ADDENDUM NO. 30 - Contract Drawing C.1

**CONTRACT 876-HP
GEOMEMBRANE CAPPING AND
GAS COLLECTION SYSTEM
PELHAM BAY LANDFILL REMEDIATION
BOROUGH OF THE BRONX
NEW YORK**

Bid Form - Contract No. 876-HP - Revised 5/25/94

LANDSCAPE PLAN

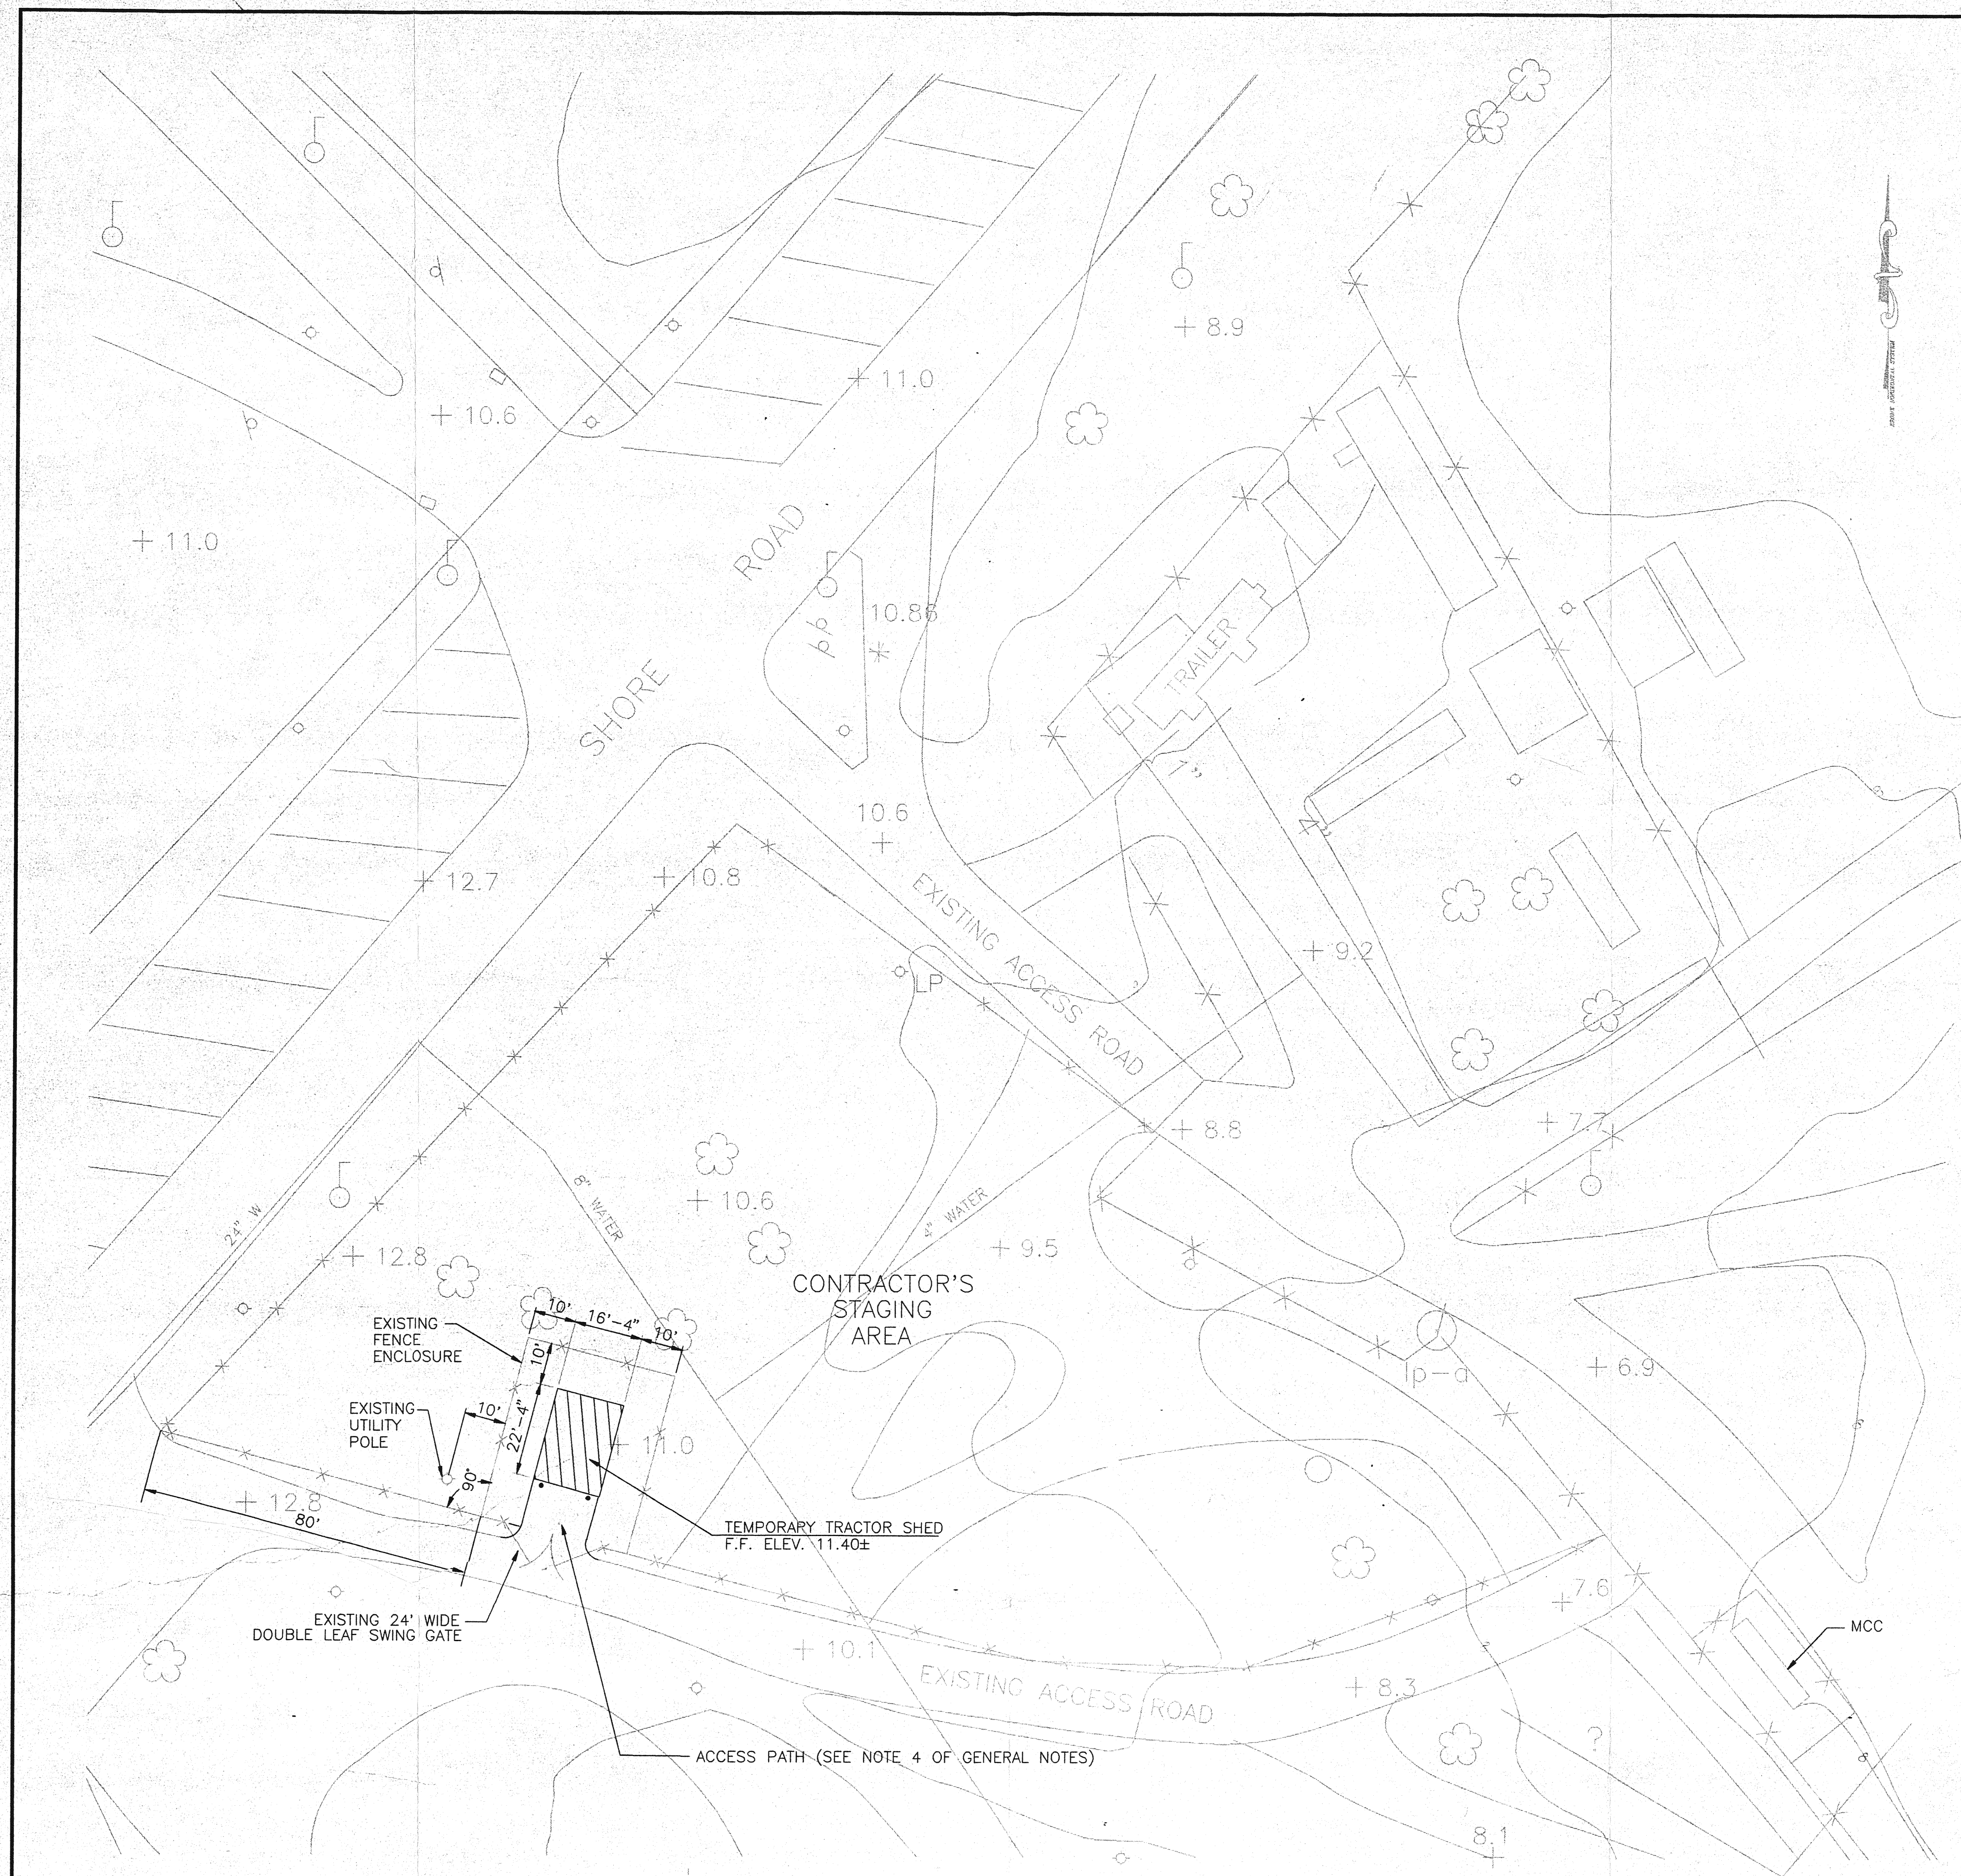
1. Replace Contract Drawing LS.1 with revised version (Drawing LS.1R1), attached at the end of this package. Revisions made to this Drawing are described below:
 - A. Add "SECTION - LIVE STAKE PLANTING" and "LIVE STAKE DETAIL".
 - B. Add "VEGETATION ISLAND FINAL CONFIGURATION - DETAIL 3".
 - C. Add "Plant Schedule for Vegetation Islands Only".
 - D. Add Notes 1, 2, 3, and 4.
 - E. Add additional planting areas on north and west sides of the landfill on the "LANDSCAPE PLAN".
 - F. Delete Vegetation Island No. 22 and renumber vegetation islands 23 through 27 to 22 through 26, respectively.

Refer to Section 02910: On p. 02910-13 there is reference to WOOD EDGING AND GRAVEL. Reference is also made to these items, plus others, as being shown on the drawings. I have only one (1) landscaping drawing, that being Sheet 27/28, LANDSCAPE PLAN, which shows the location, only, of the Vegetation Islands. Please provide the Contractor with the necessary drawings to bid and build the project.

Section 02910, paragraph 2.8 "WOOD EDGING" and paragraph 2.9 "GRAVEL" are not necessary and shall be deleted in their entirety. Sheet 27/28 of the Drawings "LANDSCAPE PLAN" has been revised as per addendum No. 40.

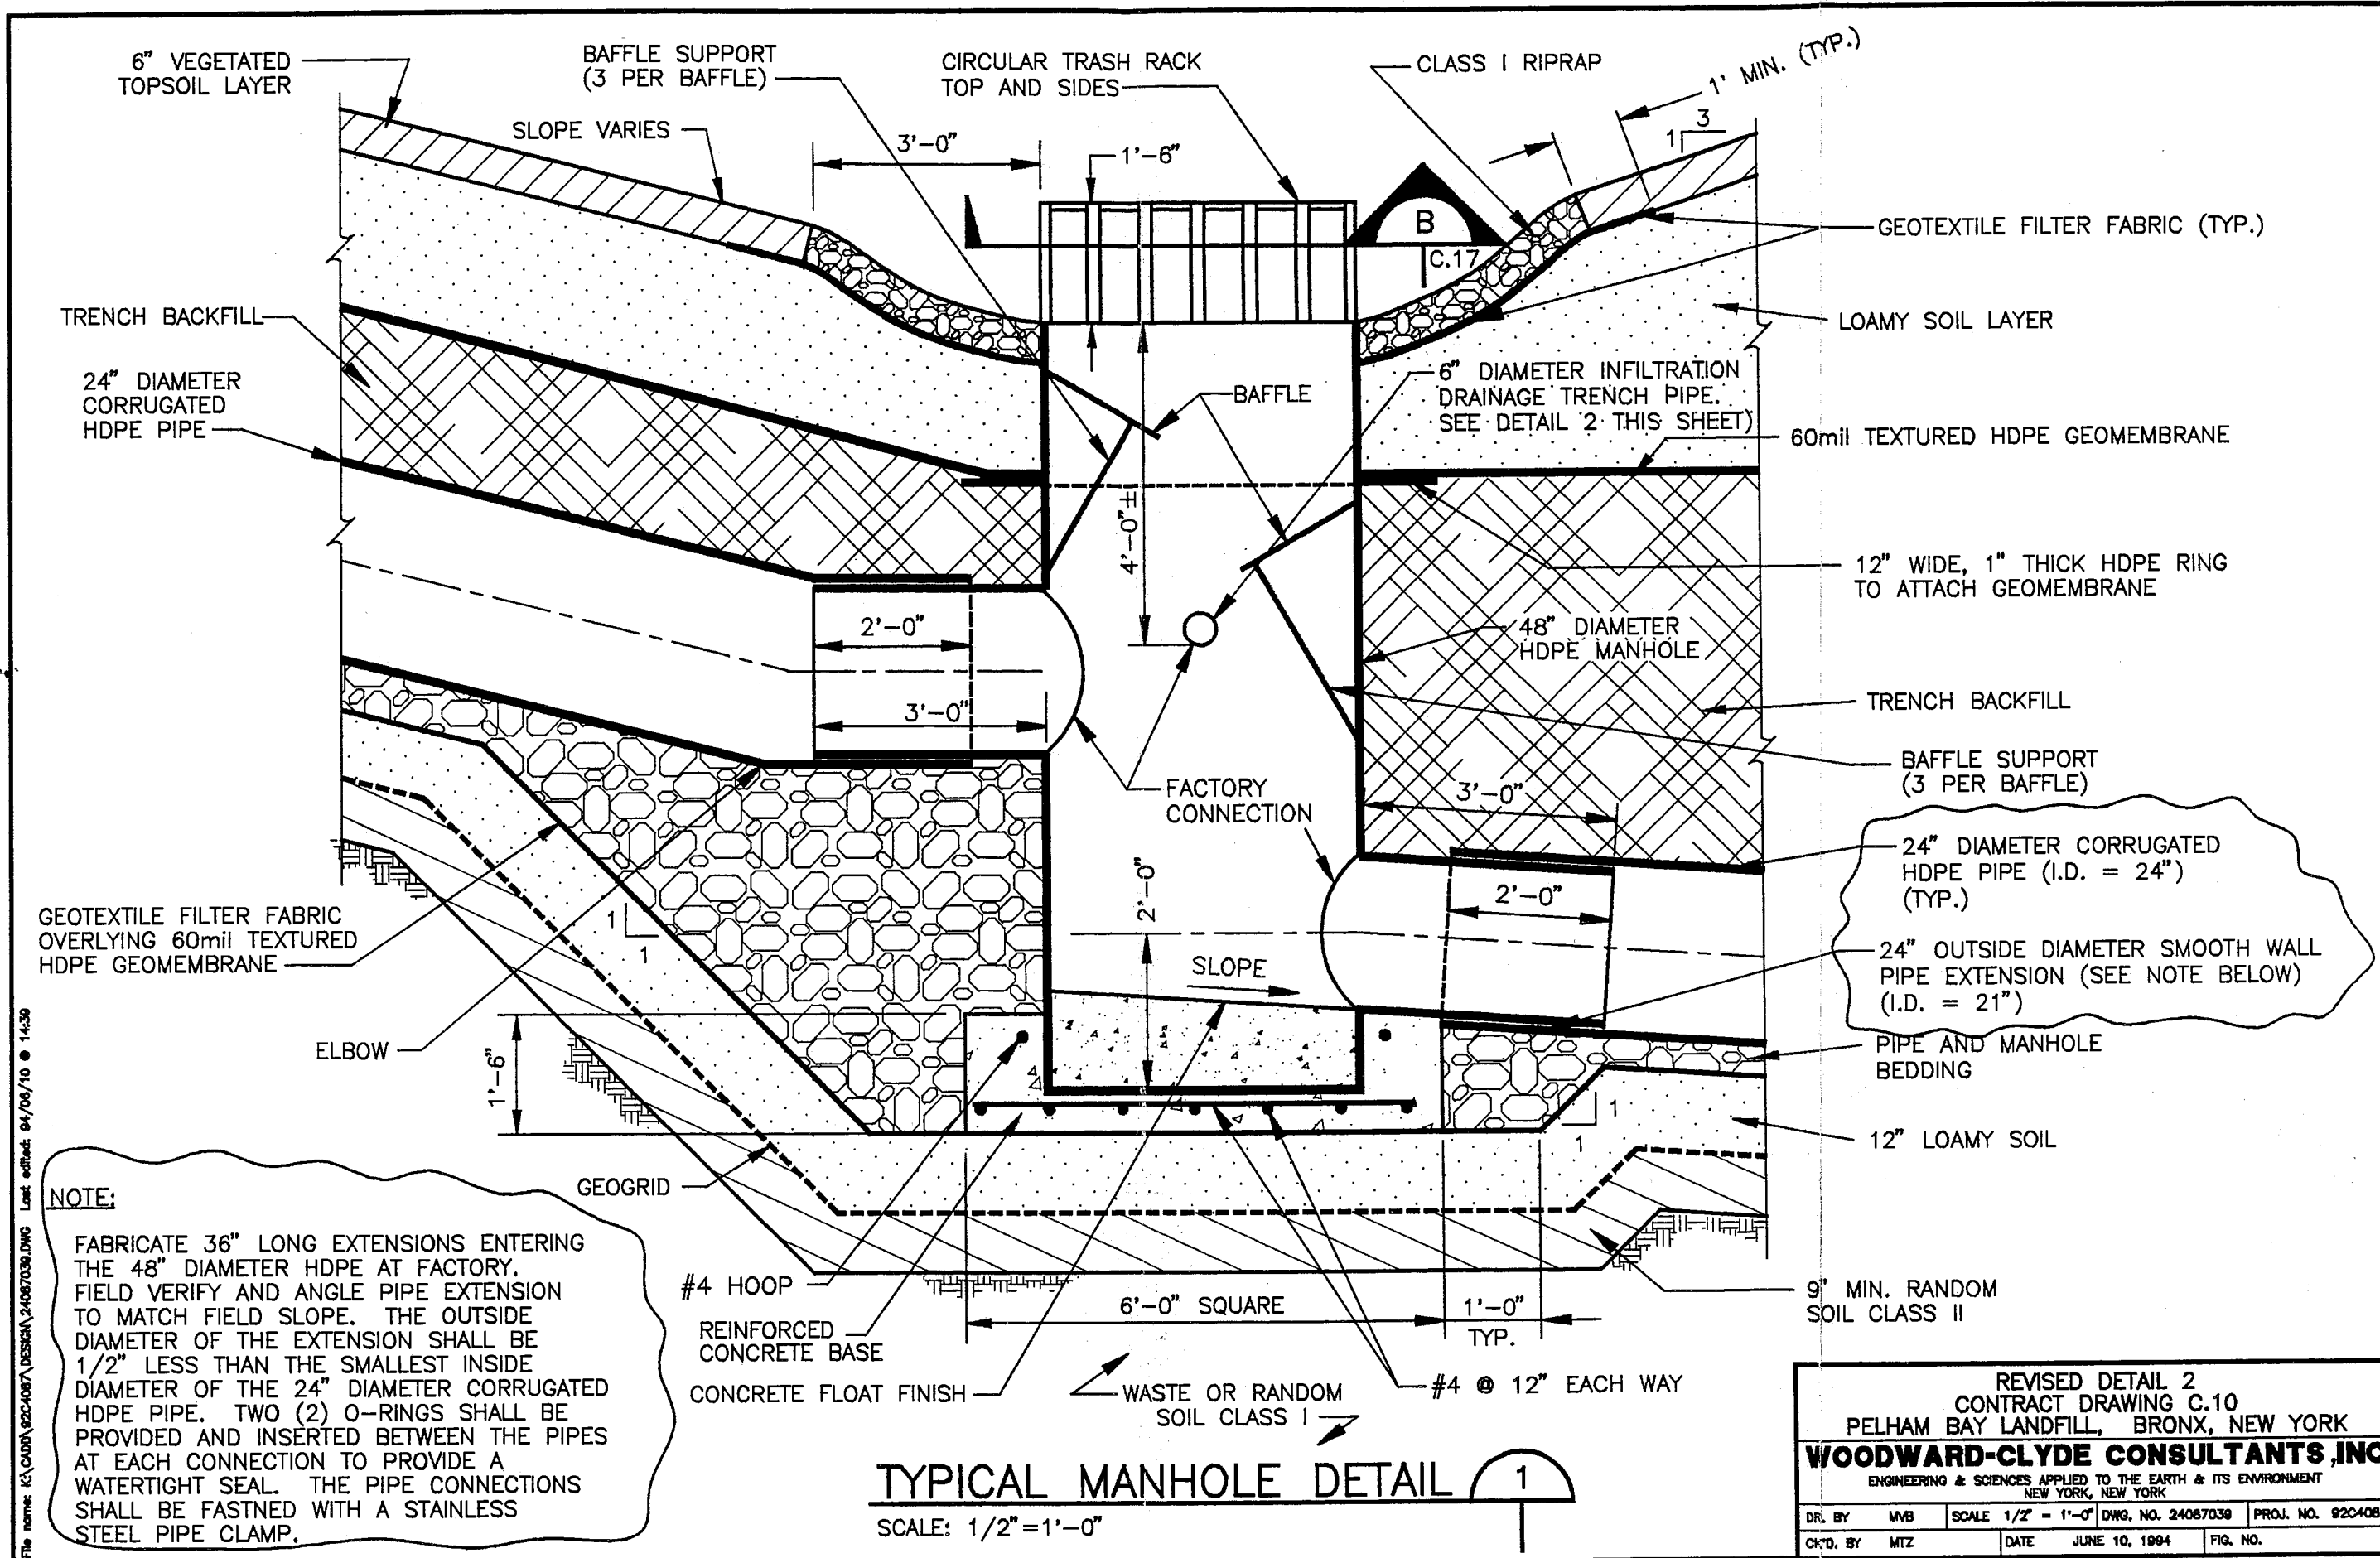
1. Delete "TYPICAL MANHOLE DETAIL 1" and replace with revised version, attached on the following page.
2. Delete "DETAIL 2" and replace with revised version, attached on the following page.

REVISED PLAN A CONTRACT DRAWING C.12 PELHAM BAY LANDFILL, BRONX, NEW YORK			
WOODWARD-CLYDE CONSULTANTS, INC. ENGINEERING & SCIENCES APPLIED TO THE EARTH & ITS ENVIRONMENT NEW YORK, NEW YORK			
DR. BY	MVB	SCALE 1/2" = 1'-0"	DWG. NO. 24087031
CHK'D. BY	MTZ	DATE	JUNE 10, 1994
		PAGE NO.

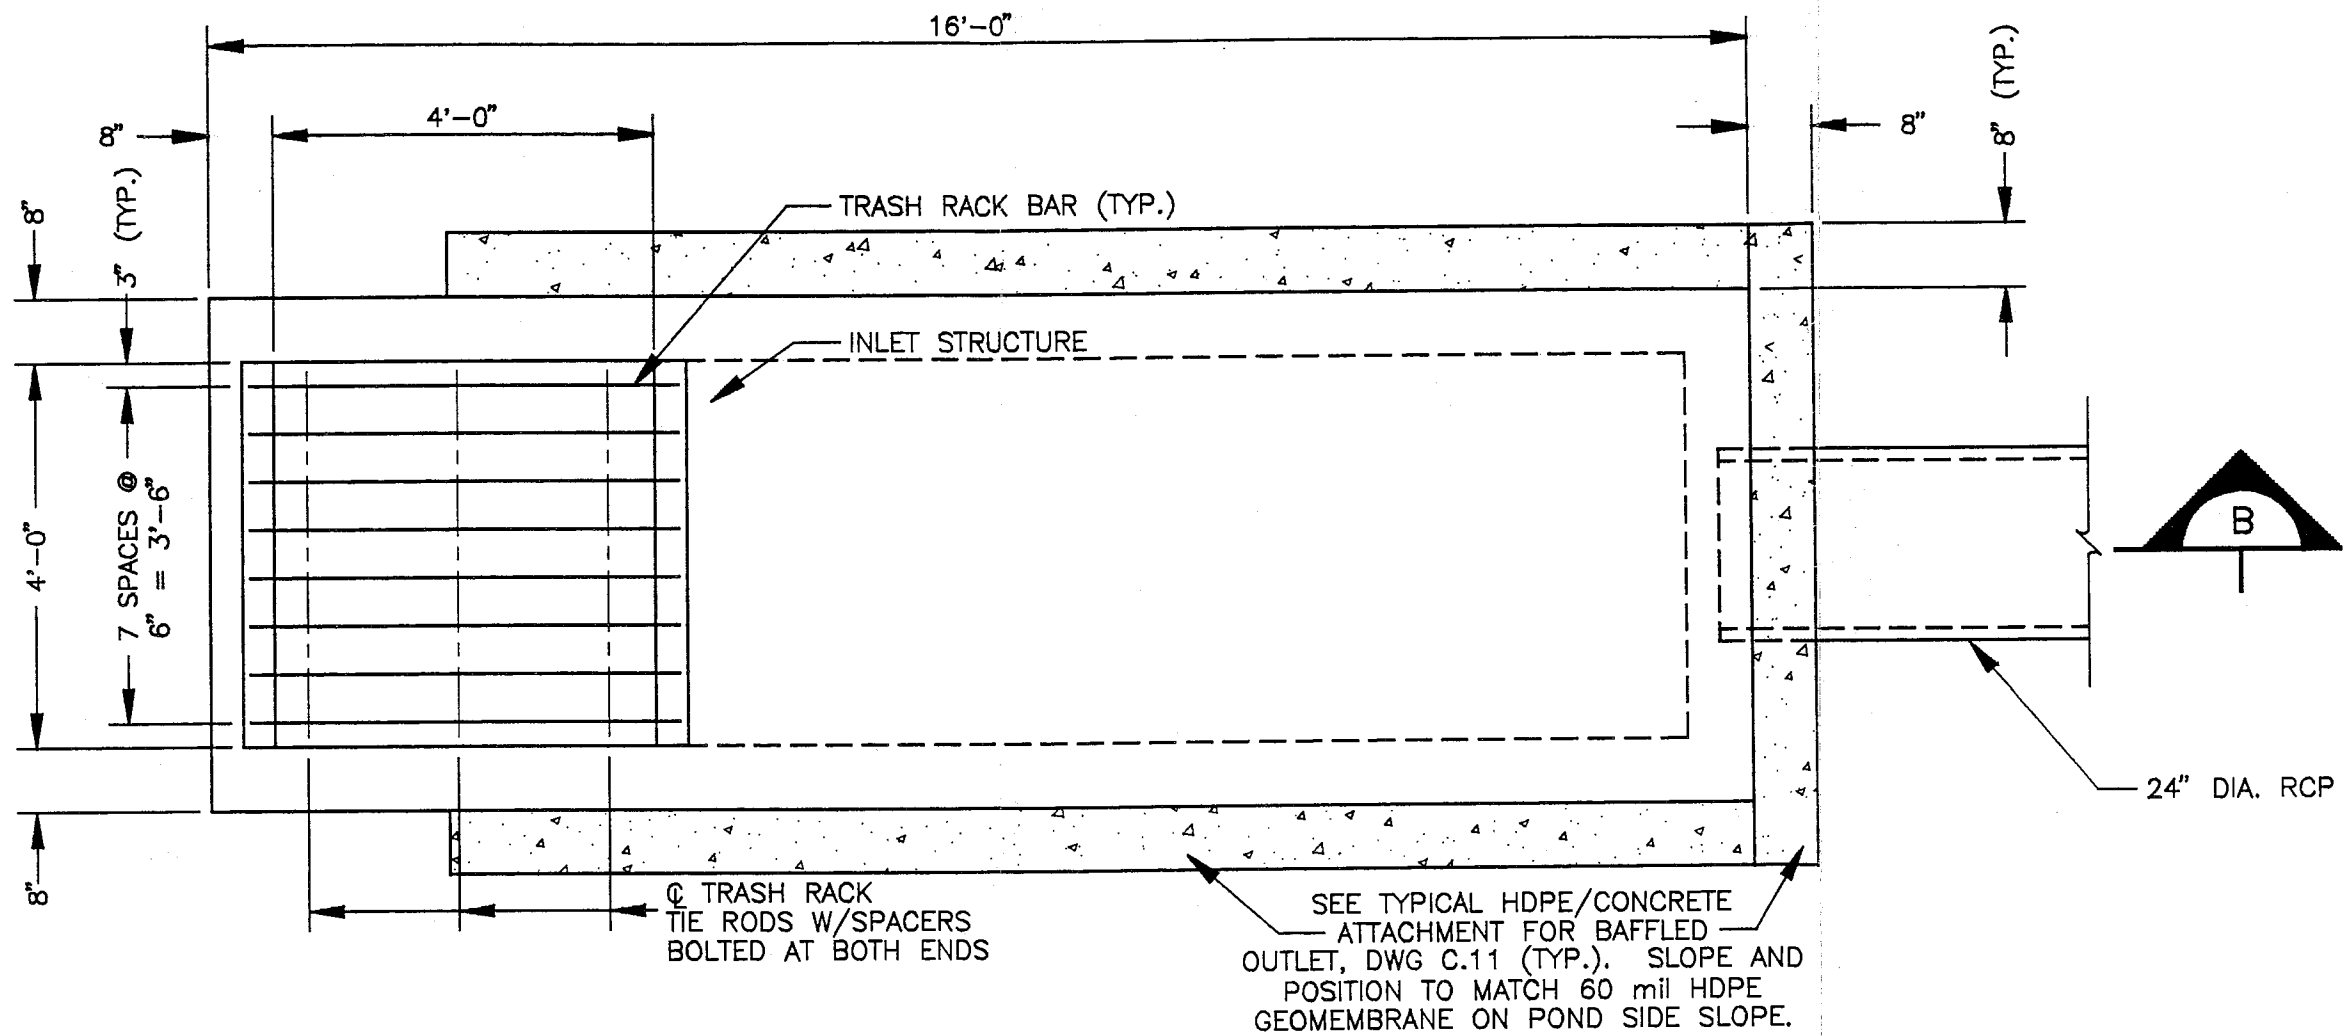
1. Delete "INLET PLAN POND C PIPE OUTLET- SECTION A" and replace with revised version, attached on the following pages.
2. Delete "INLET SECTION POND C PIPE OUTLET- SECTION B" and replace with revised version, attached on the following pages.
3. Delete "ELEVATION- SECTION C" and replace with revised version, attached on the following pages.
4. Delete "SEAT DETAIL 1" and replace with revised version, attached on the following pages.
